Subject: N212329851 - Customer Satisfaction Program
Auxiliary Control Box Labels

Models: 2021 Chevrolet Silverado 4500 HD/5500HD/6500HD
Equipped with Provisions – Electrical Switch Bank (SEO) (RPO UEH)

N212329851 Auxiliary Control Box Labels

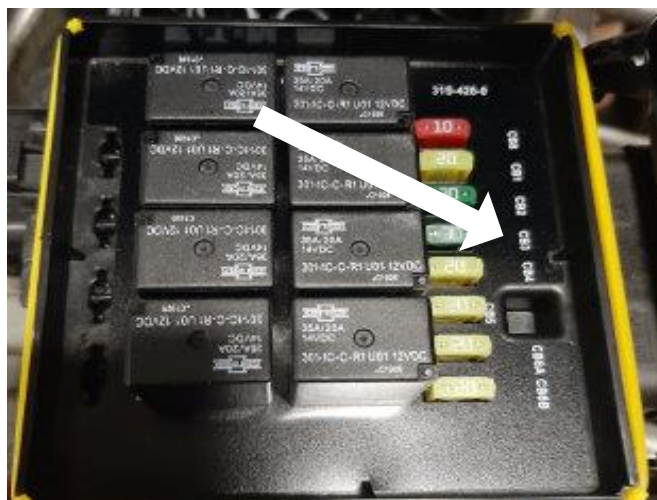
4. Install the fuse block cover label as shown. Carefully separate the label from the backing paper, do not touch the adhesive.

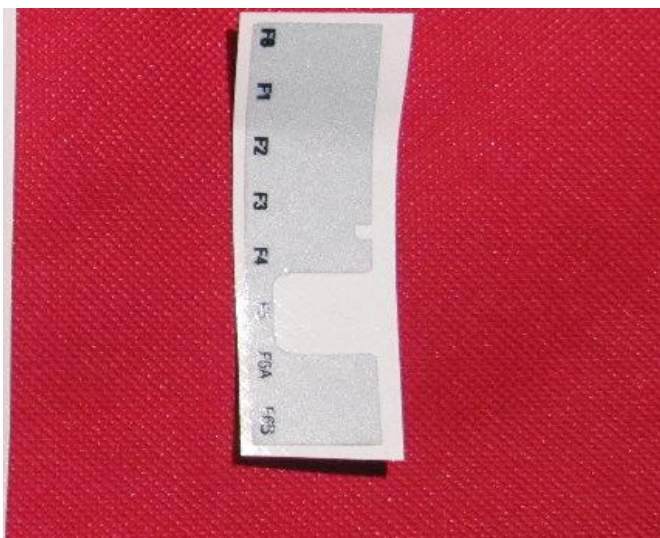
6. Install the fuse block label over the existing CB information. Carefully separate the label from the backing paper, do not touch the adhesive.
7. Close and latch the auxiliary power distribution block cover.
8. If necessary, reinstall the back-body panel carpet. Refer to *Front Seat Back Body Panel Carpet Replacement* in SI.
